Peer Review of the San Joaquin River Restoration Program's Seepage Management Plan

Independent Peer Review Panel:

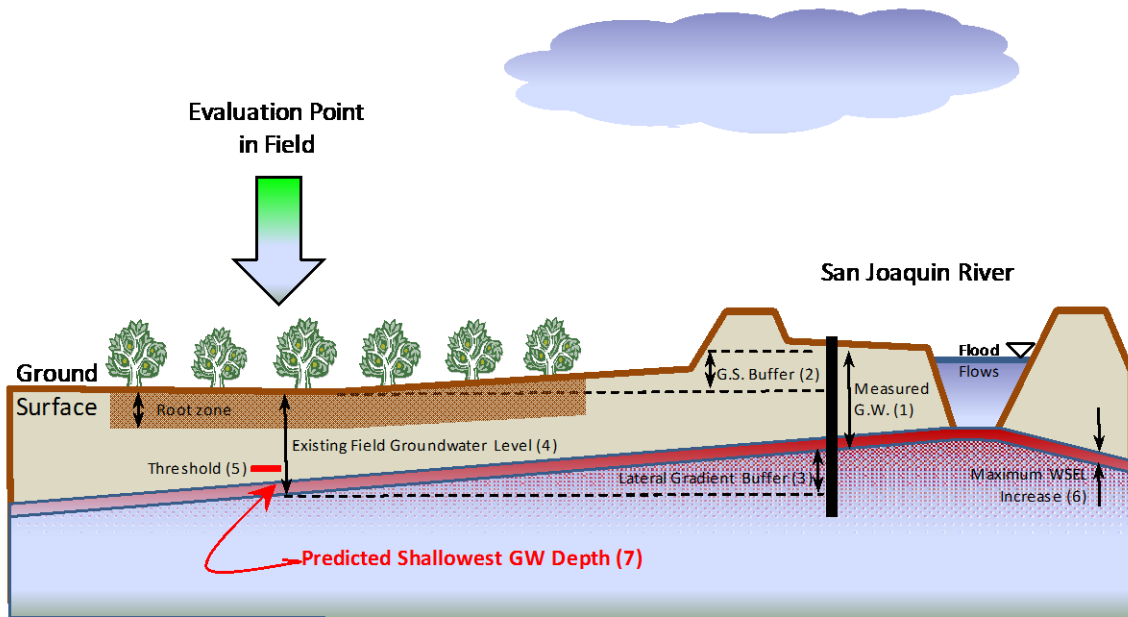
"Operations calls identified a concern regarding the amount of exchangeable demand available in Mendota Pool."

The suggested change to this type of reporting is to make the information a little less cryptic to a person not familiar with the details:

Operation Conference Call: The weekly call (Mondays at 9:15am) with SJRRP staff and the district managers/water masters resulted in a concern on the exchangeable demand in the Mendota Pool. There were no concerns listed for maintenance activities, increased flows, or water quality.

Proposed new figure for "Drainage" Method

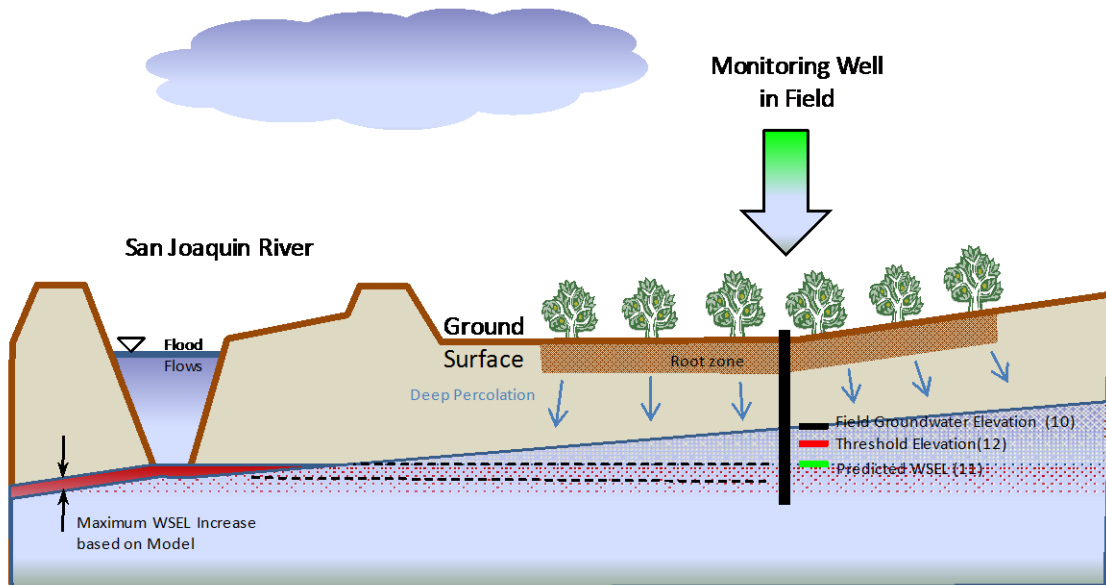
Although it may be clear to those within the SJRRP, the simple maps used to show the impact of an increase in the river stage are not very clear. It is recommended that the following figure be used to better describe the impact of a change in the river elevation.

Since it was not very clear, the PRP solicited from Katrina Harrison (Reclamation) the following clarification on the difference between the standard method and the drainage method:

The standard method (or "increase in stage method") is calculated as follows:

- Measured depth of the water table below ground surface in the well, converted to a depth bgs (below ground surface) in the field by applying the difference between field and well ground surface elevation (if any)
- Calculated water surface elevation from HEC-RAS at the future flow level, minus the elevation at the existing flow level (i.e., delta h)
- Measured depth bgs in the field, + delta h = predicted depth bgs in the field at the future flow level
